We thank the reviewer for her/his comments. We note that the reviewer comments refer to a previous version of the document. Those comments were already addressed. Below are our *previous* responses to them in [blue](#).

This manuscript described a feasibility study of a differential absorption radar operating near a water vapor absorption line (183 GHz) in measuring total column water vapor from space. The considered radar system combined two tones (167 & 174.8 GHz) near the vapor absorption line and had potential radar powers ranging from 0.1 to 100 W. The radar system performances including measurement approaches and environment conditions were numerically simulated based on basic radar principles and global CloudSat observed hydrometeor and ECMWF atmospheric temperature, pressure and humidity profiles. Various measurement sensitivities and uncertainties were simulated. Results showed that with 20 W radar transmitted power satisfied measurements could be obtained for both land and ocean areas. This kind of satellite measurements could potentially provide additional global water vapor observations, particularly over land, besides passive infrared and microwave vapor soundings ove

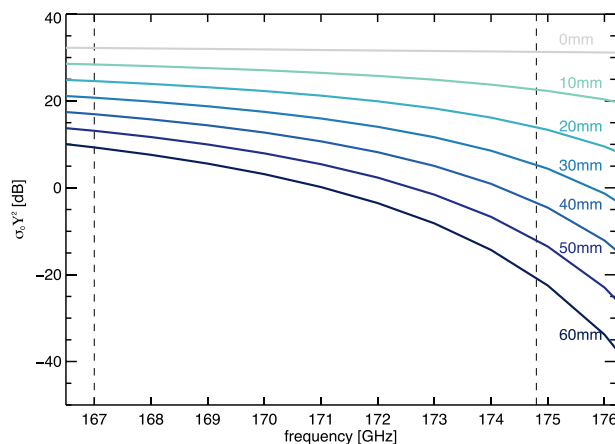
14. Pg5, L16: For radar operation frequencies of 167 and 174.8 GHz, could the authors let readers know how big the atmospheric gaseous attenuations at these frequencies are for some typical clear atmospheric profiles such as those with total column water vapor values of 35, 45 and 55 mm? What are the percentages of vapor attenuations on the totals?

[We included a new figure:](#)

At the end of that paragraph we added: As examples of this burden, Figure 2 shows the spectral variation of the surface return for different total column water vapor burdens under clear sky conditions. The spectral contrast between 174.8 and 167GHz varies from 0.1dB for no water vapor to 31dB for 60mm of total column water vapor.
